CITY OF ALBUQUERQUE

RE: **GAHP Silver Downtown**
800 Silver SW
Grading Plan Engineer's Stamp Date: 1/30/2017
Hydrology File: K13D013

Based upon the information provided in your submittal received 2/10/17, the Grading Plan is not approved for Building Permit. The following comments need to be addressed for approval of the above referenced project:

A5 ENLARGED GRADING PLAN
1" = 10'-0"

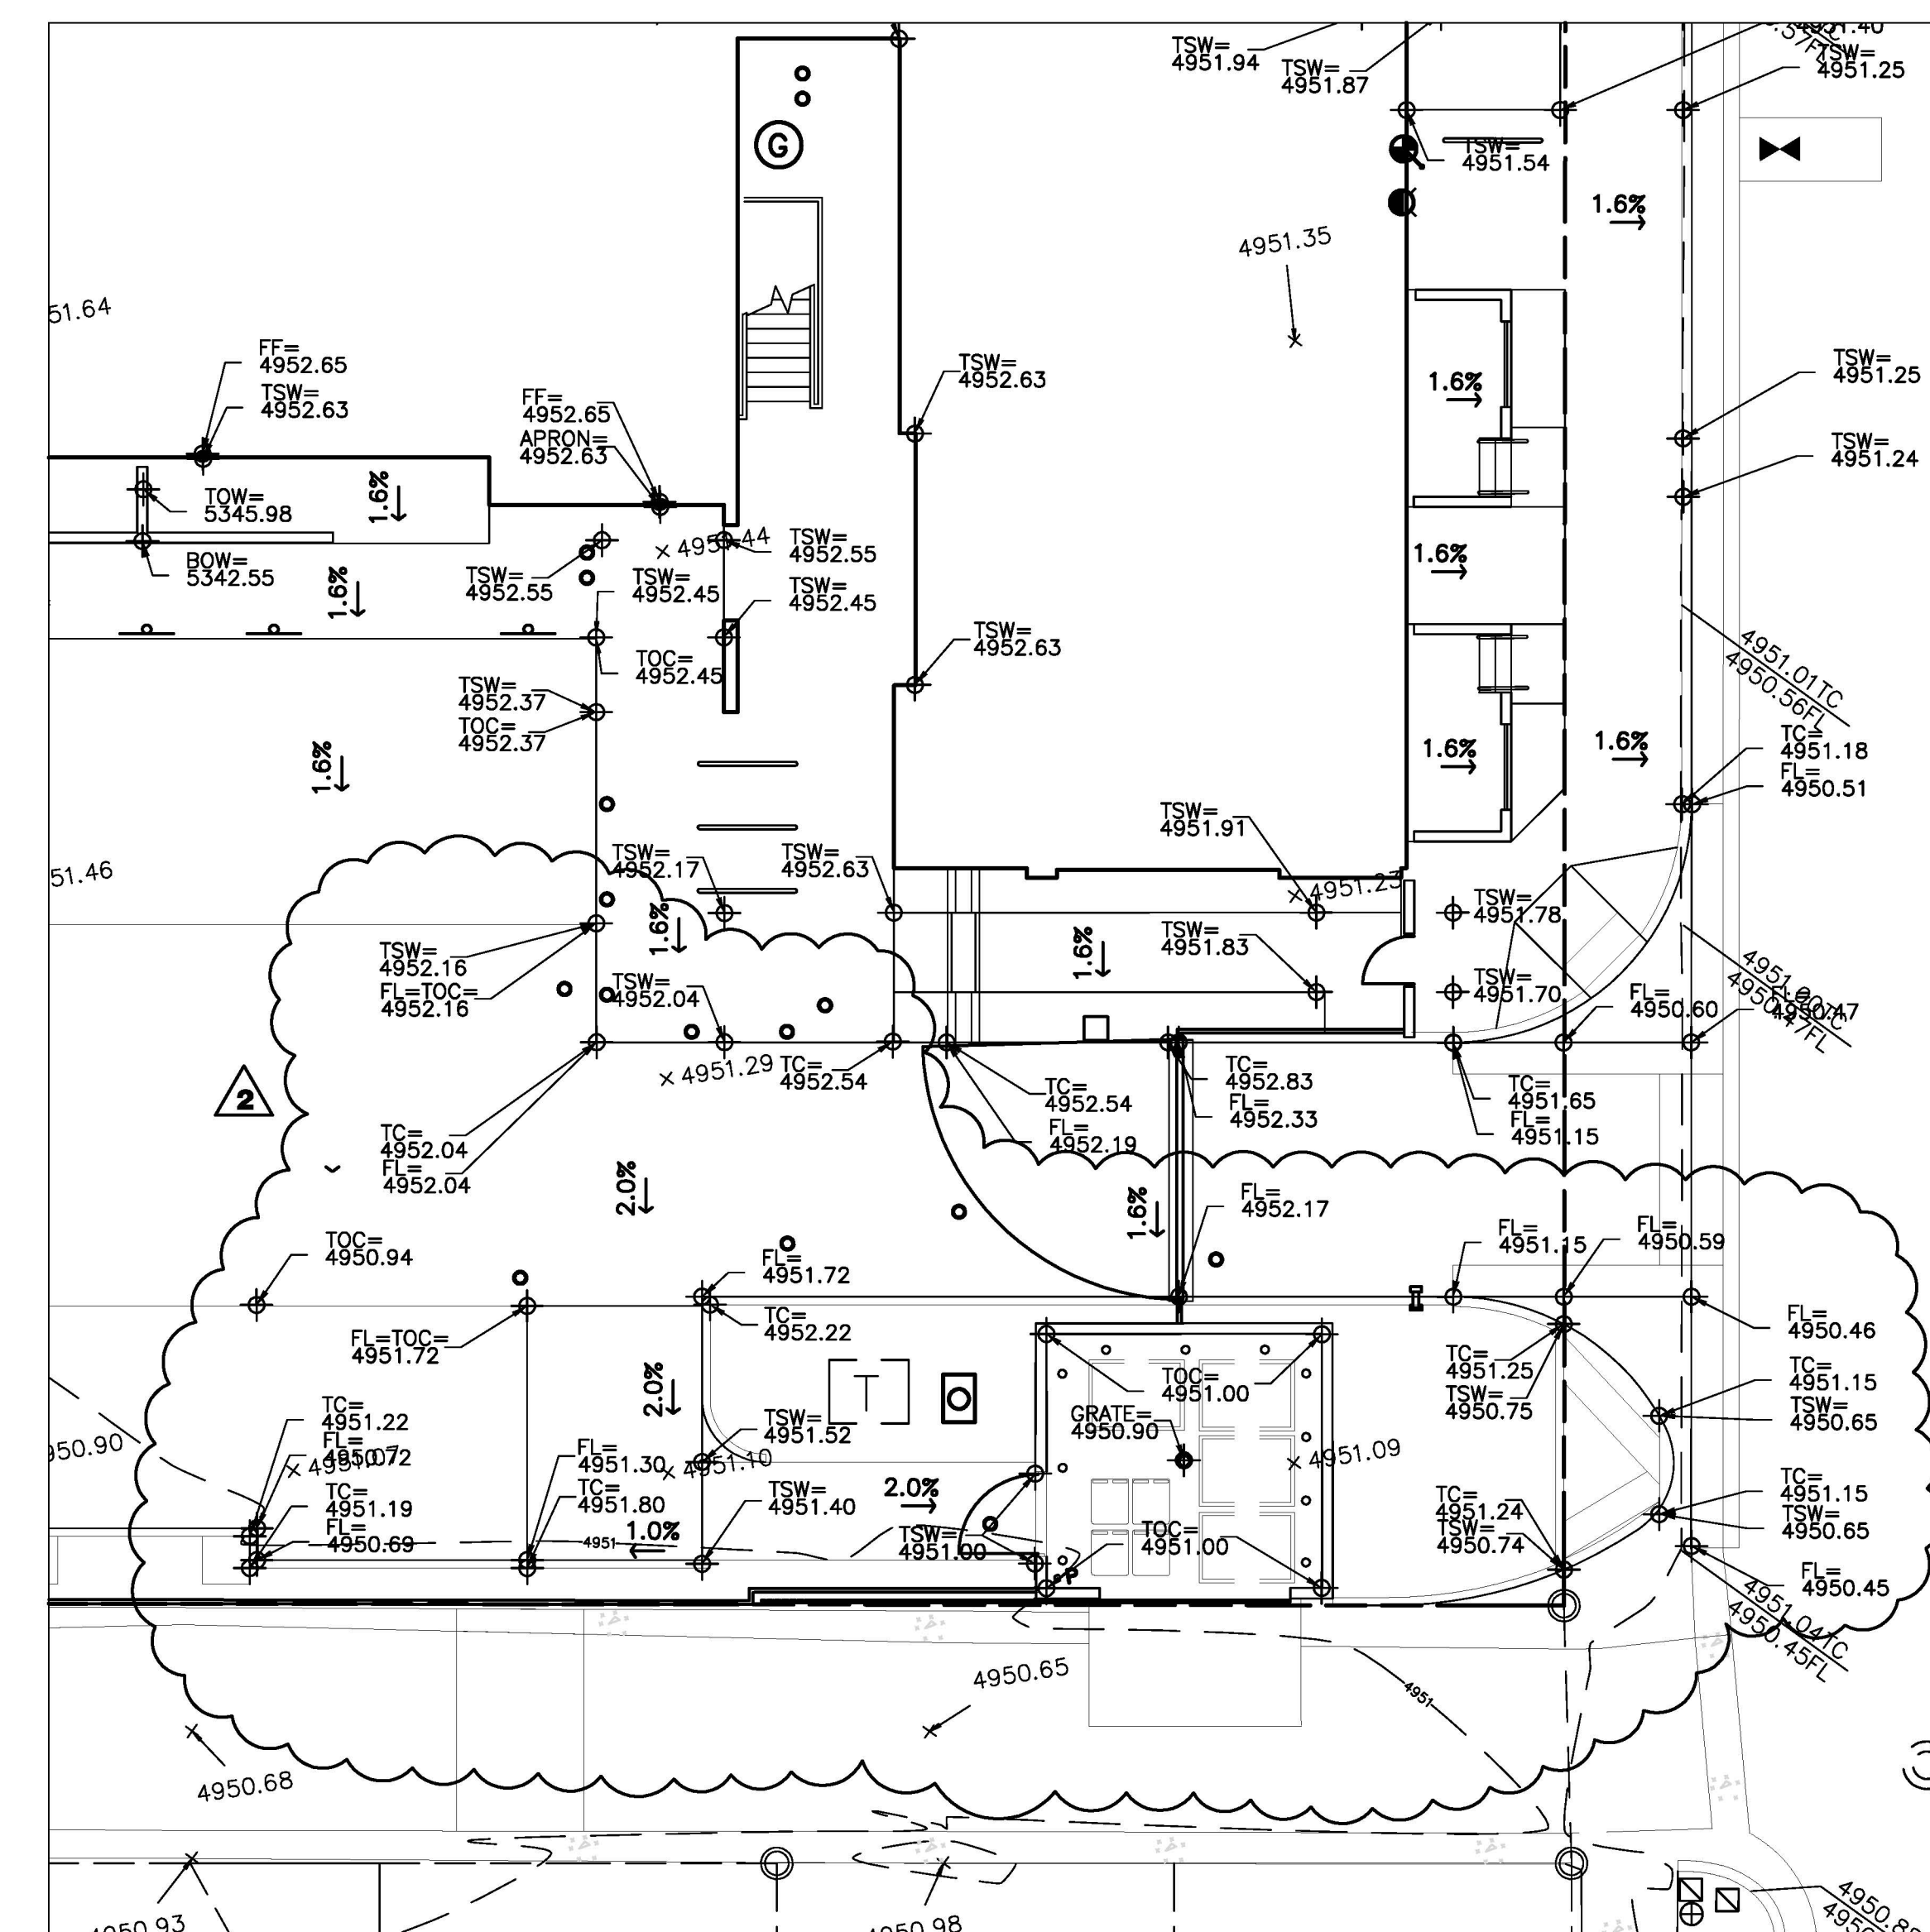
7. There is a grate elevation shown in area A5. Is there an interior storm drain network or is this to plumb the trash area into the sanitary sewer?
